INTERNATIONAL STANDARD

AMENDMENT 1 AMENDEMENT 1

Energy management system application program interface (EMS-API) – Part 301: Common information model (CIM) base

Amendment 1 to IEC 61970-301:2020 has been prepared by IEC technical committee 57: Power systems management and associated information exchange.

Figure 12 – Transformer and Tank model

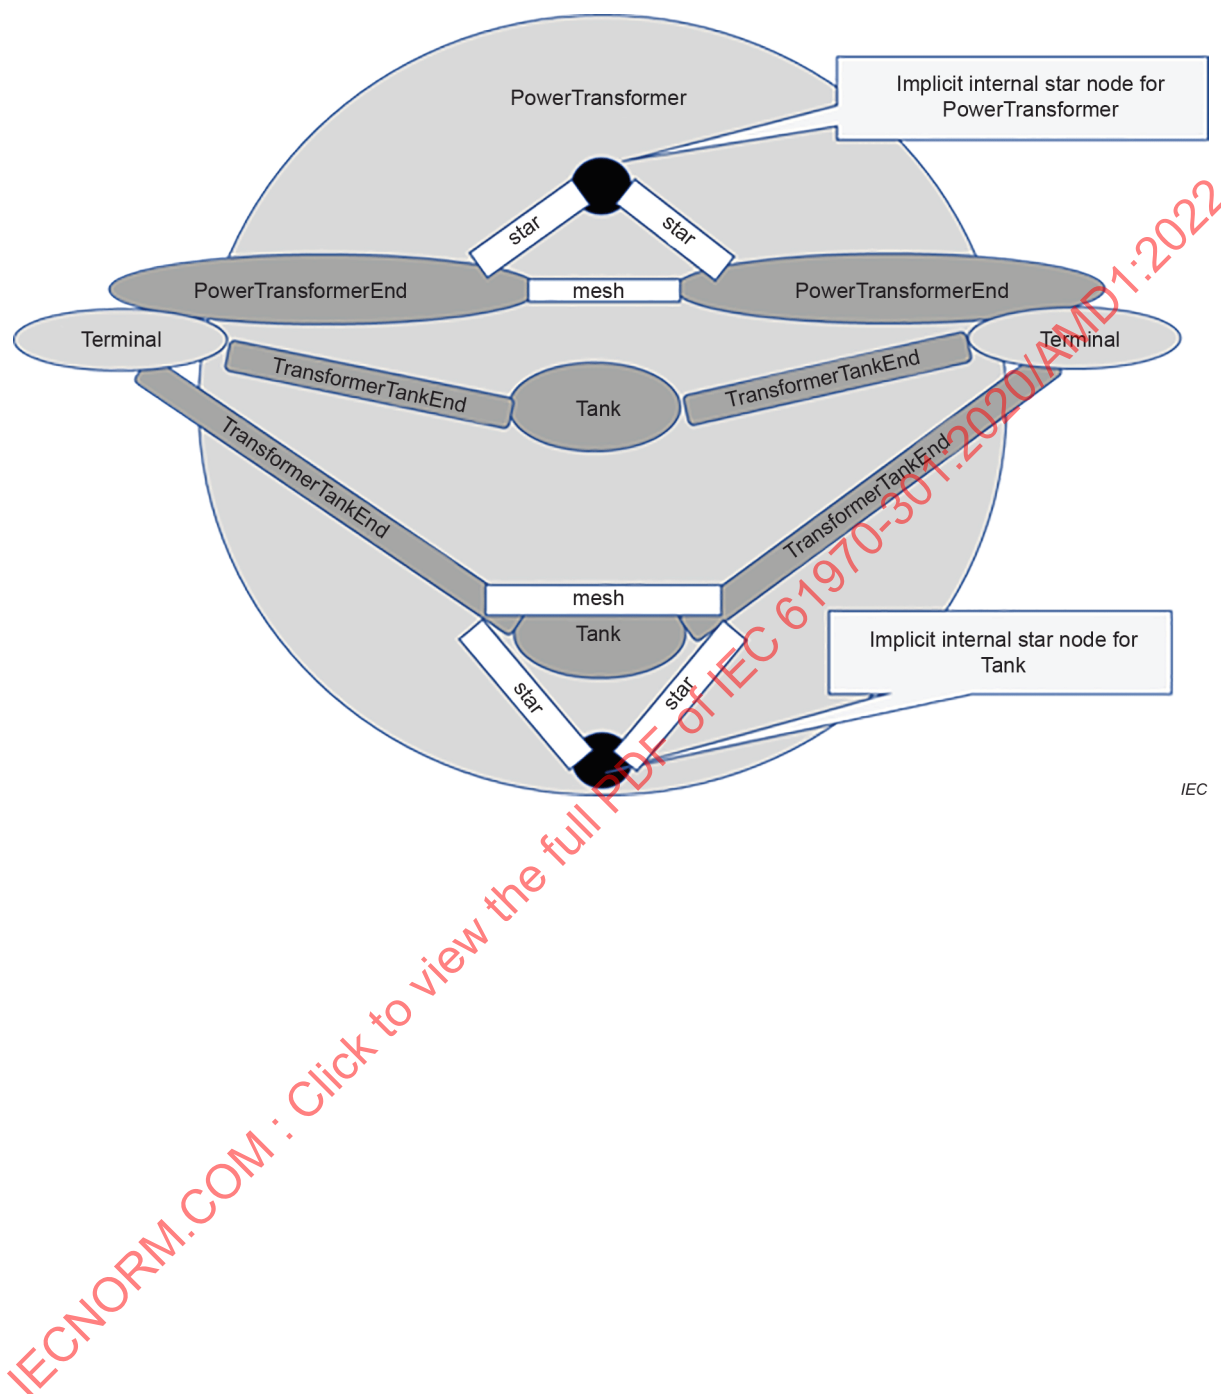
Replace the existing Figure 12 with the following new figure:

Figure 36 – Regulating control models

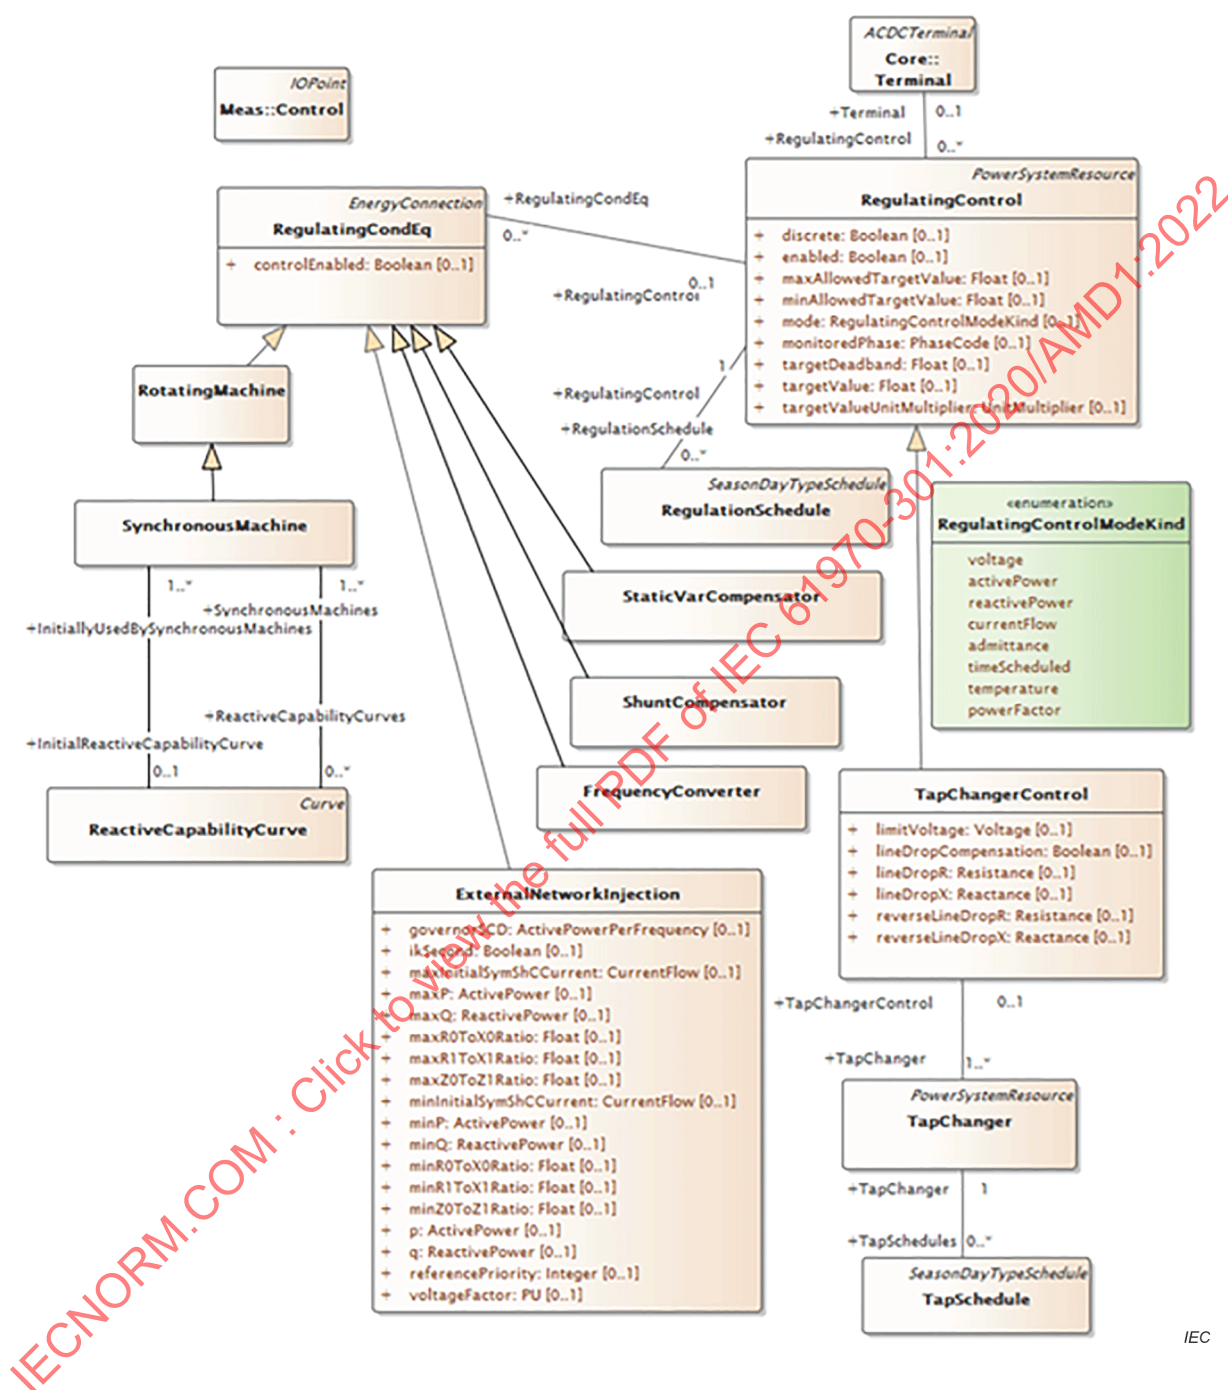
Replace the existing Figure 36 with the following new figure:

Figure 12 – Modèle de Transformer et Tank

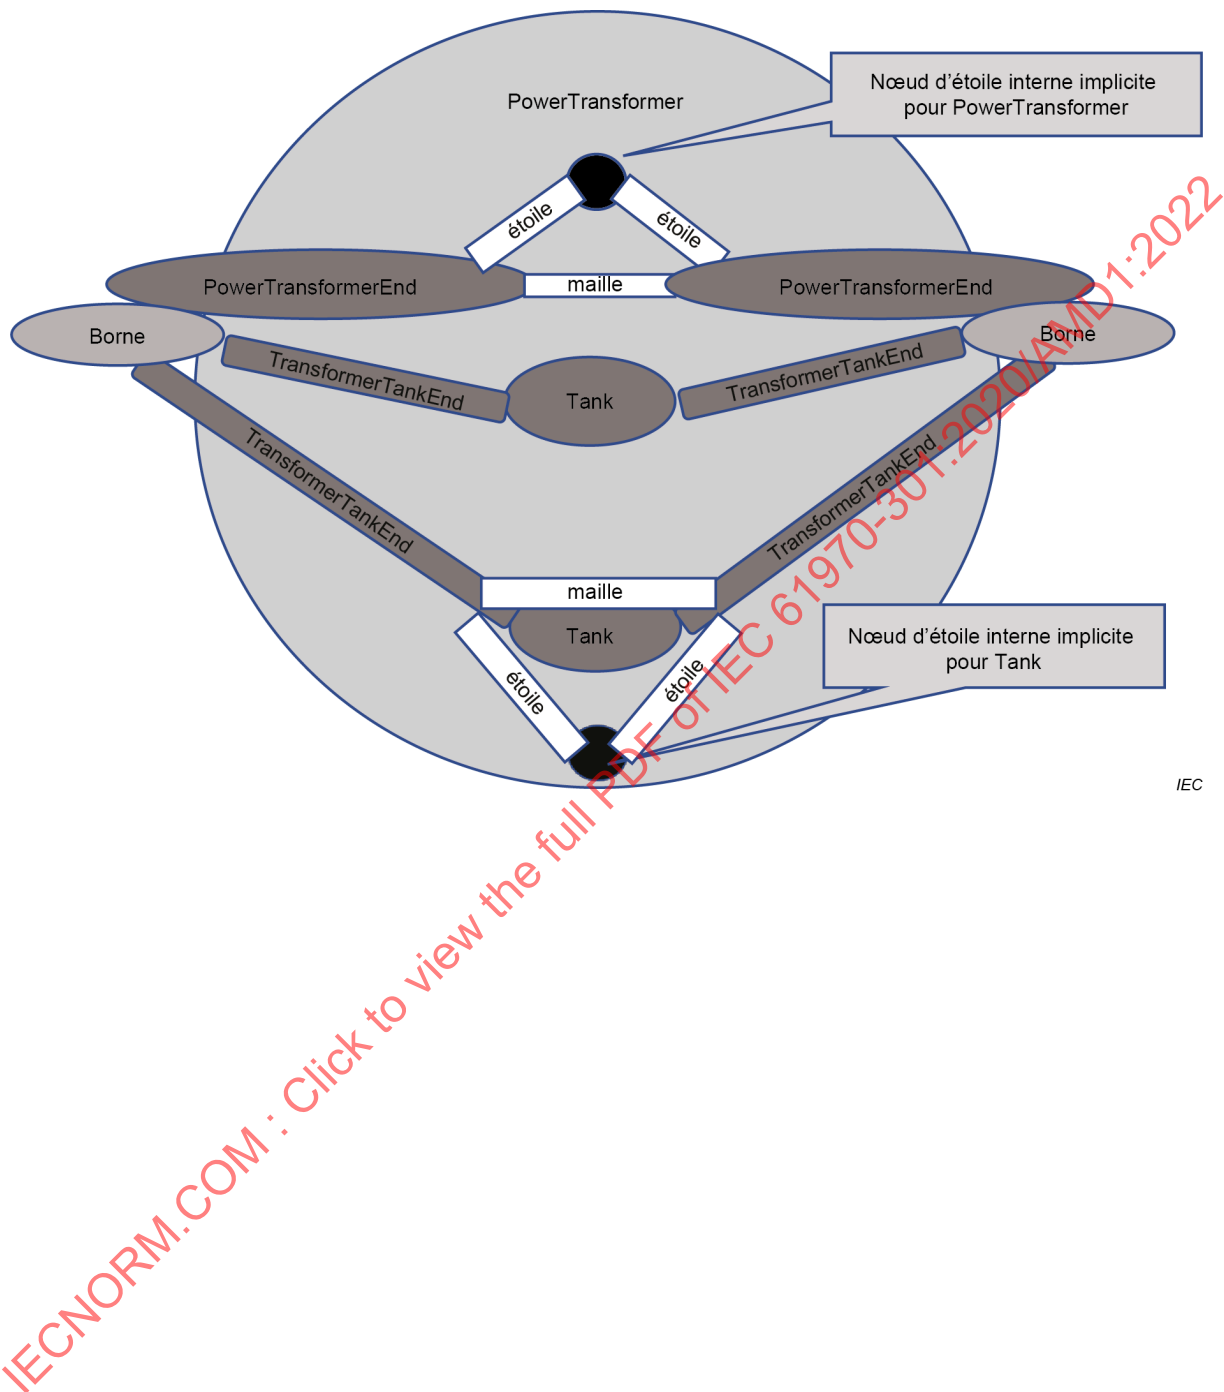
Remplacer la Figure 12 existante par la nouvelle figure suivante:

Figure 36 – Modèles de commande de régulation

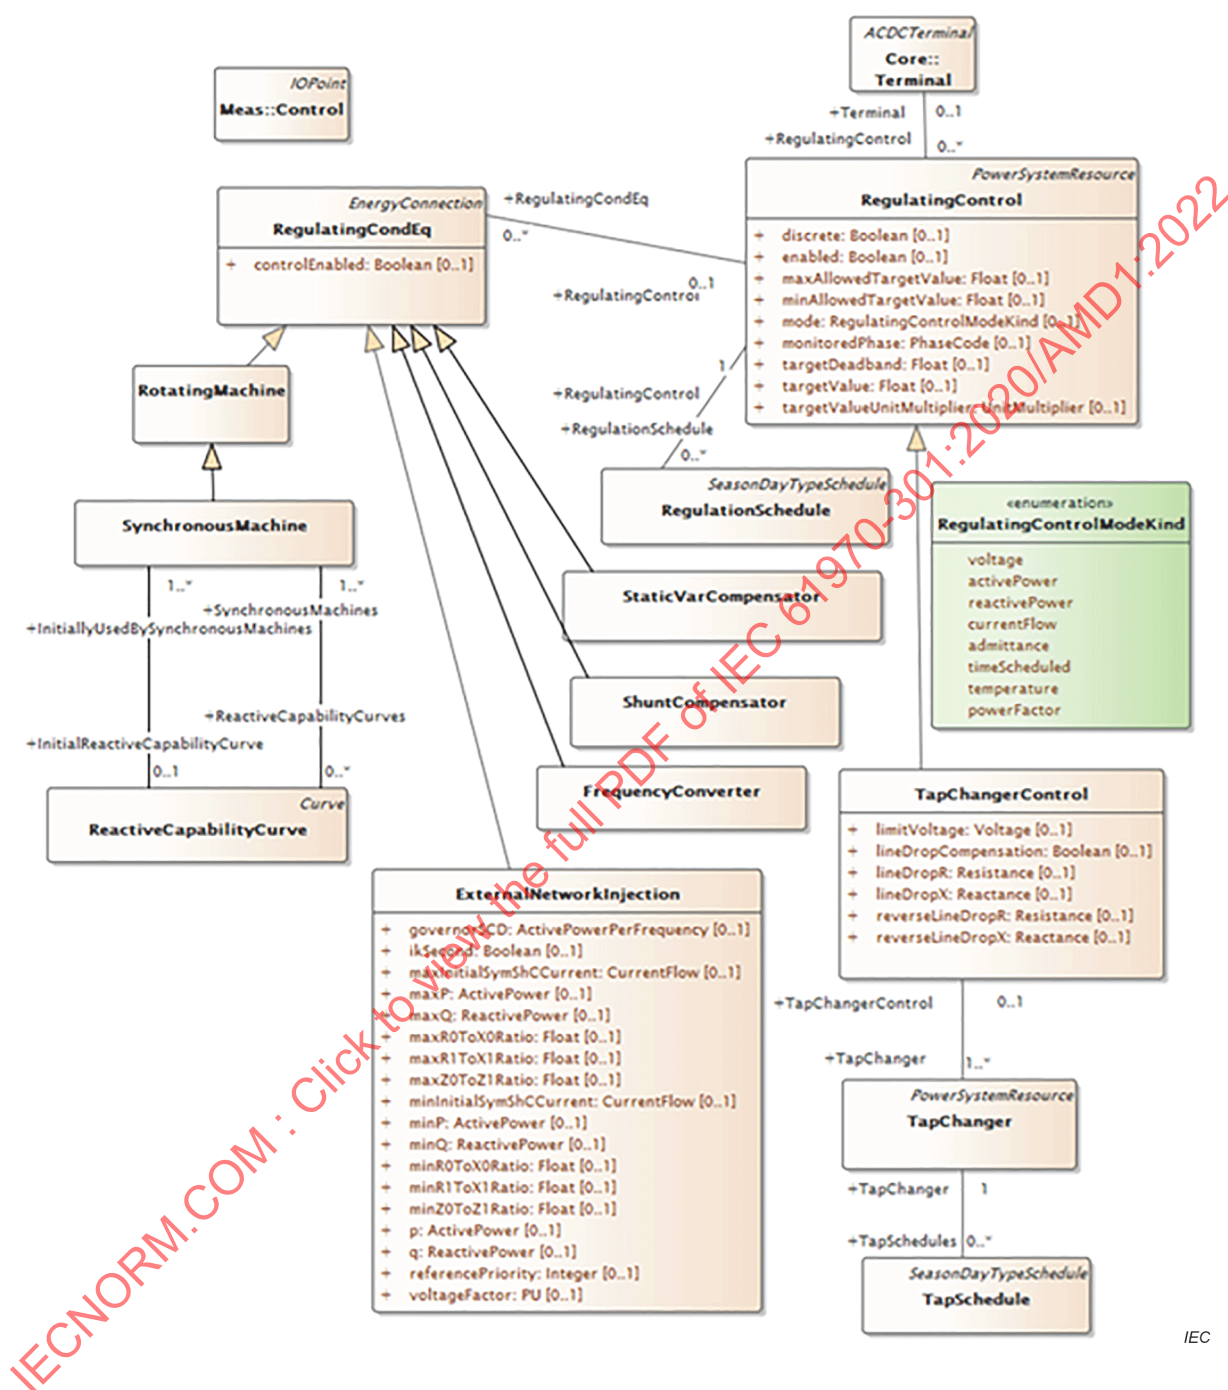
Remplacer la Figure 36 existante par la nouvelle figure suivante:
